MEMORANDUM

B1 - MEANS OF ESCAPE OBSERVATIONS

PREMISES: Grenfell Tower, Grenfell Road
APP No: Submission 1
SUBMISSION No: S1
DRAWING No: 1279(08) 101 01 BS, 100 01 BS.

RBKC MOE - S1
Comments to be used by RBKC Building Control

1279 (08) 101 01 BS

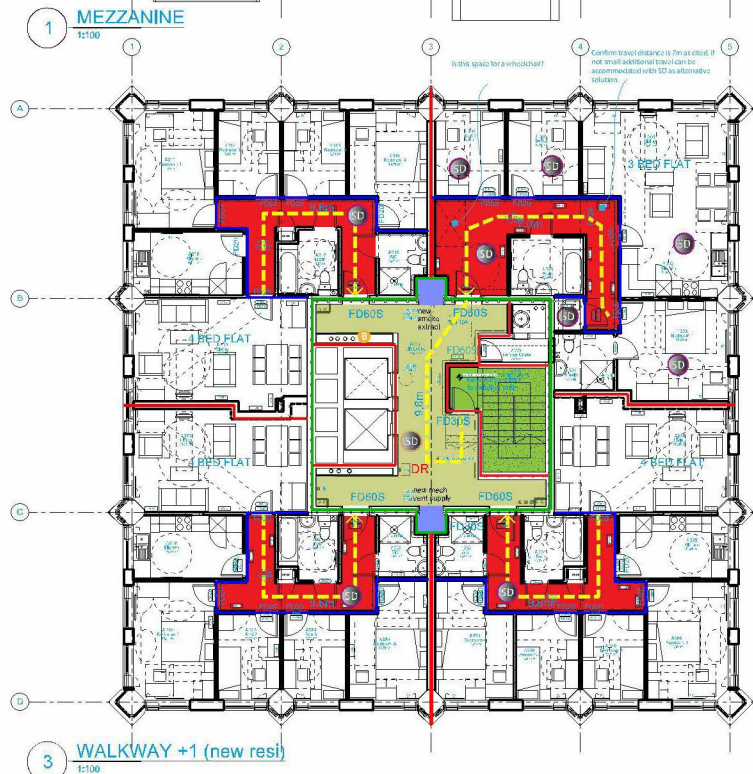
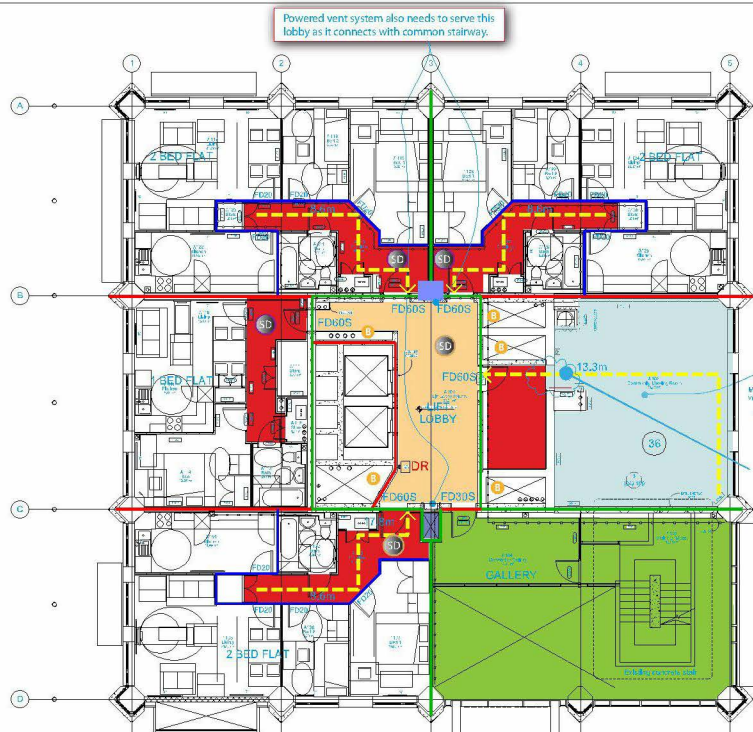
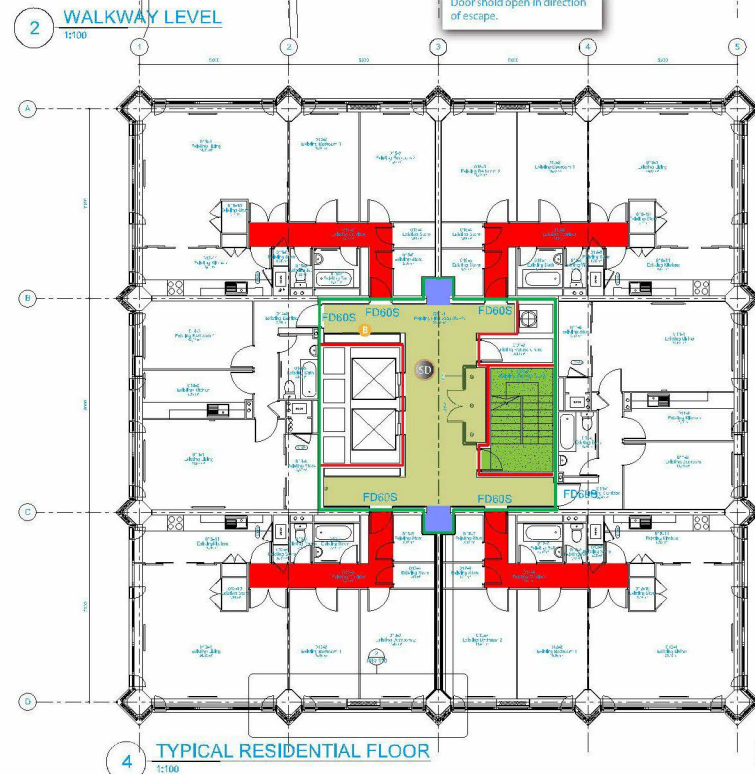
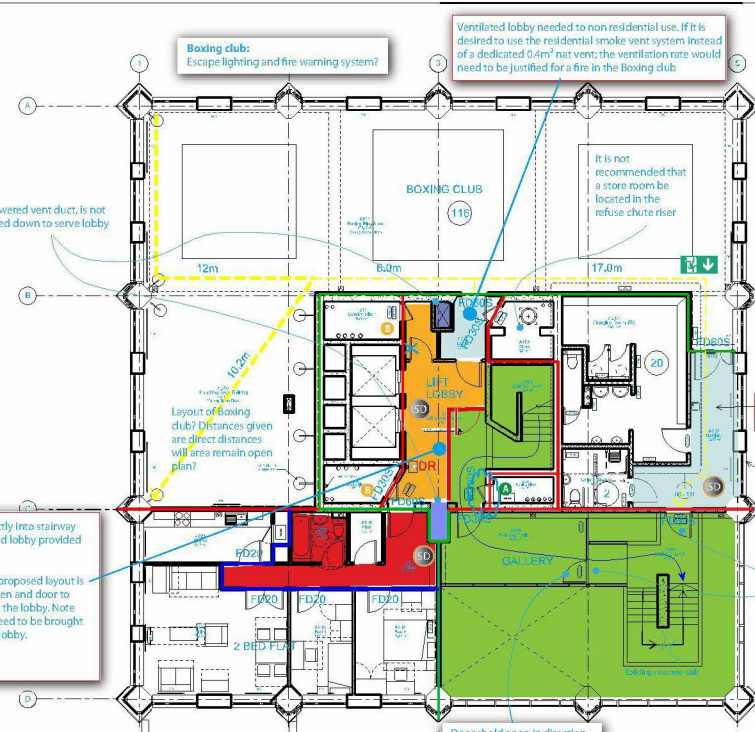
The revised residential use at walkway level opens directly into the stairway without a ventilated lobby – the plans have been marked up with a suggestion, to separate the stairway from the lobby.

The 0.4m² ventilated should be reintroduced for the revised access points to the residential stairway. See marked up plans.

Due to the reconfiguration of the stair and lobbies, some riser shafts open directly in to the stairway. This arrangement should be avoided. Is access to the risers necessary at this level (see marked up plans with symbol 'A' for these areas). Access to common lobbies is acceptable as identified by symbol 'B'.

No details of existing extract / supply rates are given therefore no consideration could be given of adverse effect on existing system.
If system designers wish to redesign the system without consideration of adverse effect, justification for the proposed extract rate needs to be submitted, including performance modelling.

Access should not be provided to services from the single stairway.
(Hot and cold water/dry riser services are acceptable in metal pipes with suitable fire stopping). (Note in the existing building these risers were in the lobby). Can these access panels be sealed at this level?

Fire resistance should be achieved from the riser side of the enclosure. Access to services from the lobby should be via an FD305 with Fire Door Keep Locked Shut Signage.

Note for the purpose of means of escape this area is the stairway (shown in green). Therefore all accommodation access to boxing club needs vent lobby protection.
